Vehicle Headlamp Levelling

Measurement data of several vehicles
equipped with automatic levelling
Influence of the components of the system

Headlamp levelling – review of proposals

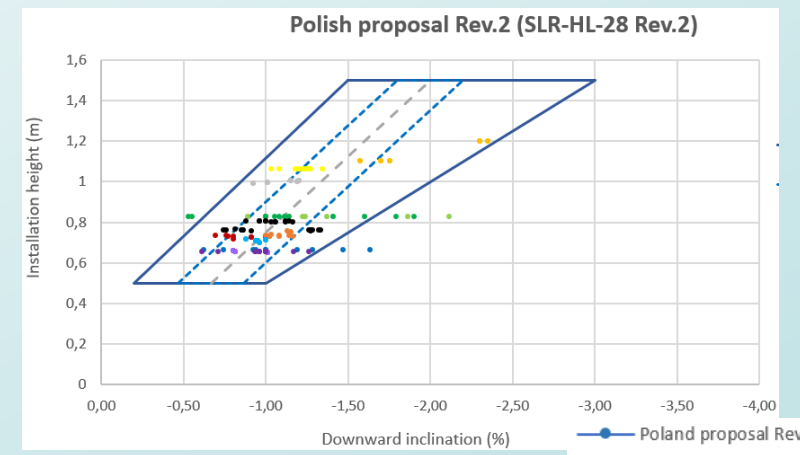
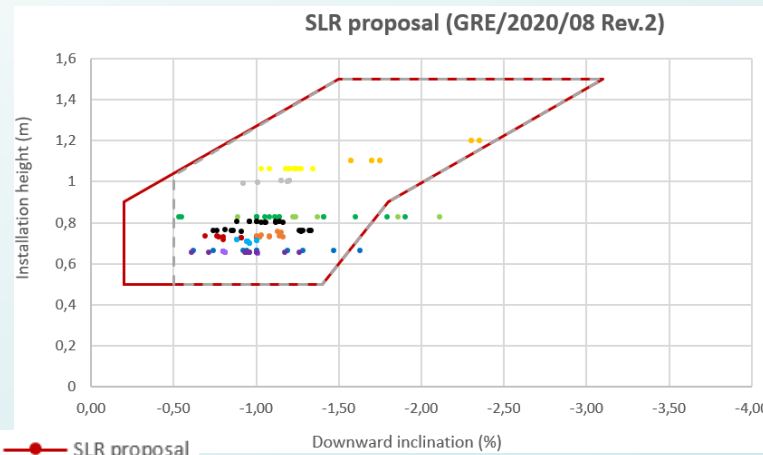
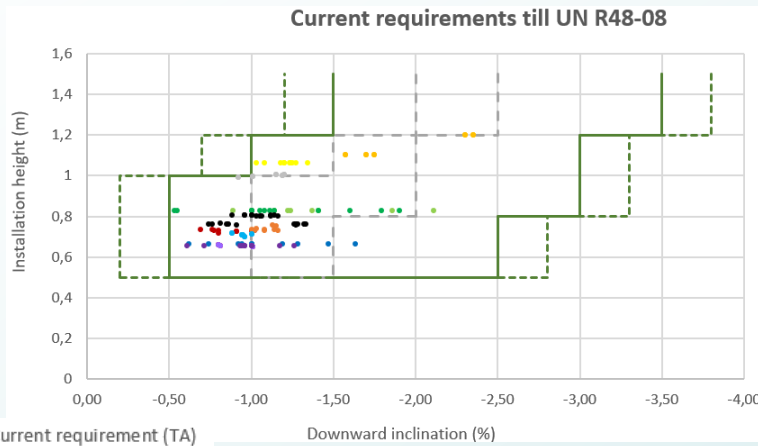
Current requirements	SLR proposal	Revised Poland proposal	SLR ideas for compromise
Document	As in UN R48 today	GRE/2020/8/Rev.2 (link)	SLR-HL-28-Rev.1 (link)	SLR-HL-30 (link)
Levelling devices	Manual and automatic devices are allowed	Automatic device mandatory (except off-road vehicles)		
Diagram for TA				
Initial aiming	in accordance with diagram (dashed grey lines)	$\leq -0.5 \%$, in the box limits (dashed grey limits)	$I = -h/0.75 *$ (dashed grey line)	Idea #1 : $\leq -0.5 \%$ in box limits Idea #2 : $I = -h/0.75 *$ (dashed lines)
CoP requirements	Additional tolerance (dash green lines)	As TA requirements	As TA requirements	As TA requirements

Headlamp levelling data vs requirements

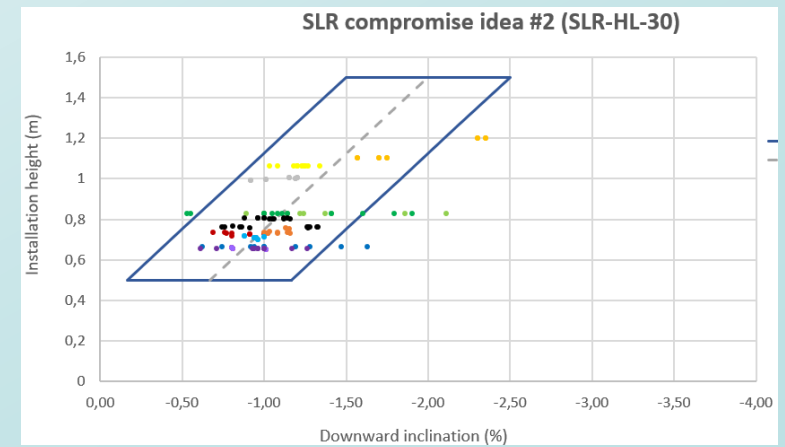
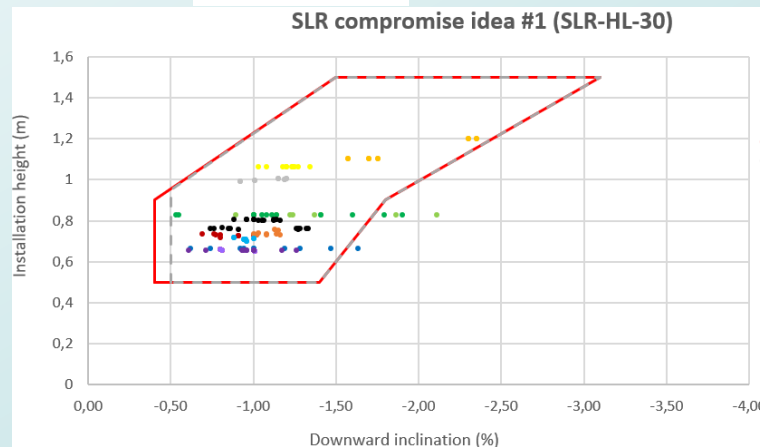
- Gathering of vehicle headlamp levelling data (dedicated format)
- Data results, representative of type-approval measurements, plotted in the various diagrams (last update with SLR ideas for compromise and revised Poland proposal SLR-HL-28 Rev.2)

● Poland proposal Rev.2
- - - Recommended requirement
- - - Initial aim

Analysis of measurement data

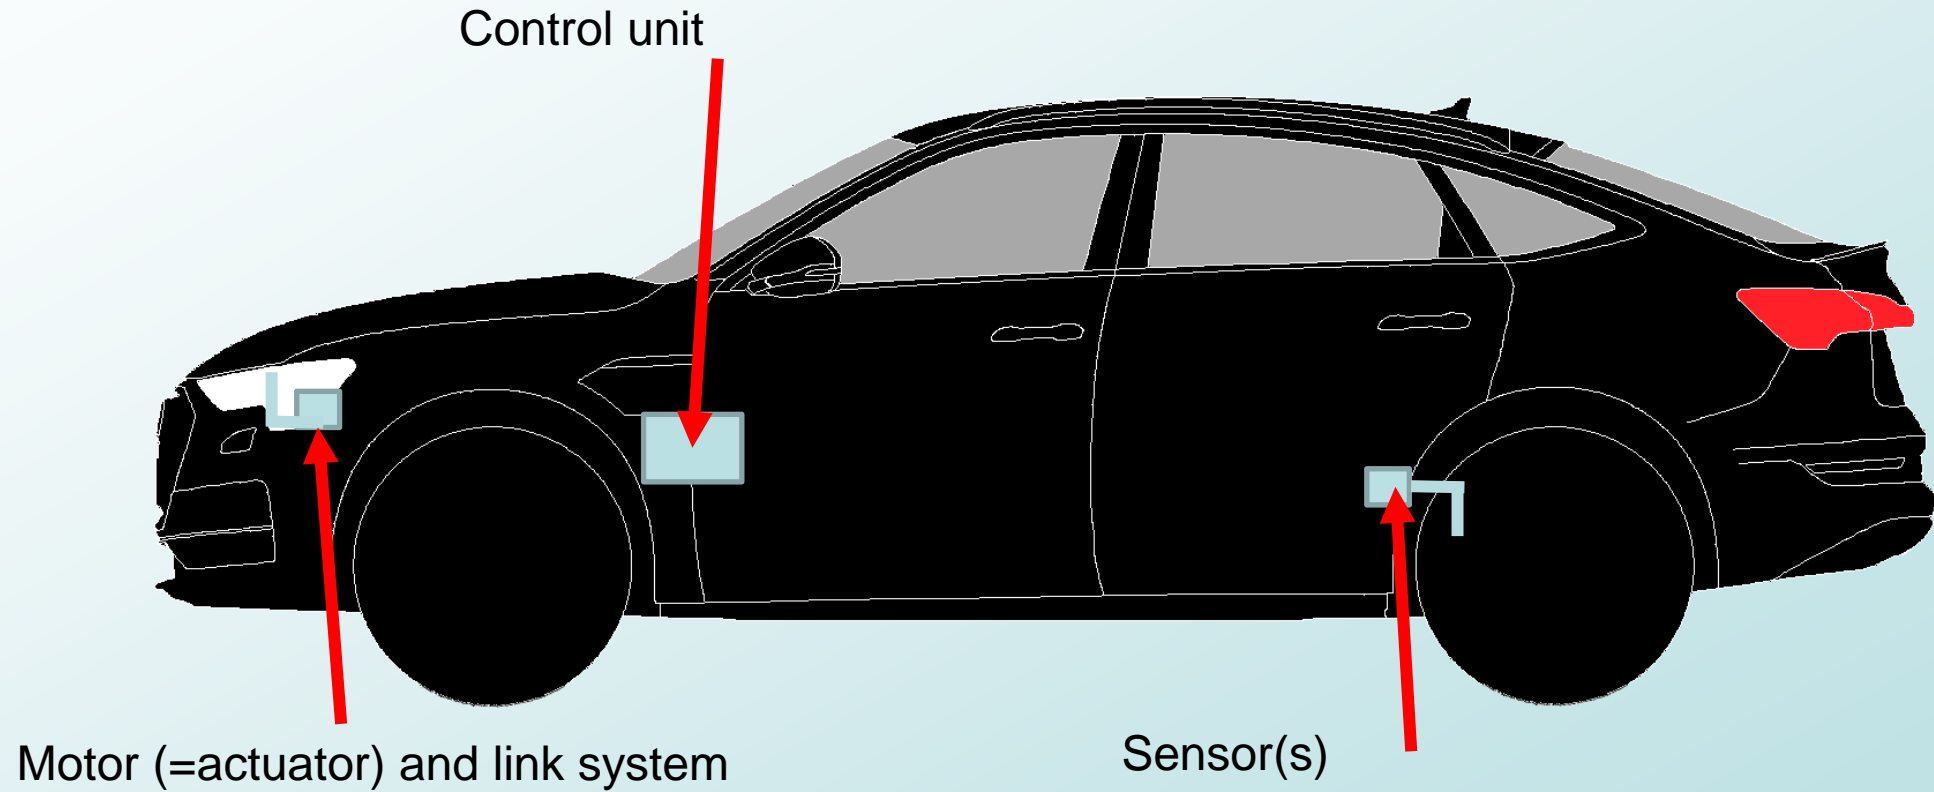
- The requirements of the SLR proposal (GRE/2020/08 Rev2) can be met with existing automatic levelling devices, except for some truck categories.
- The linear line proposed by Poland for initial aiming does not reflect the corresponding marking to be written with increments of 0.1%.
- In addition, variants within types and production tolerance result in a height variation that would mandate different markings.
- An automatic levelling system is designed to work for all variants of a vehicle model (basic & fully equipped), to remain within the aiming limits for all loading states.
- The data representative of trucks shows the large diversity of installation heights on a vehicle range, for a same headlamp model.
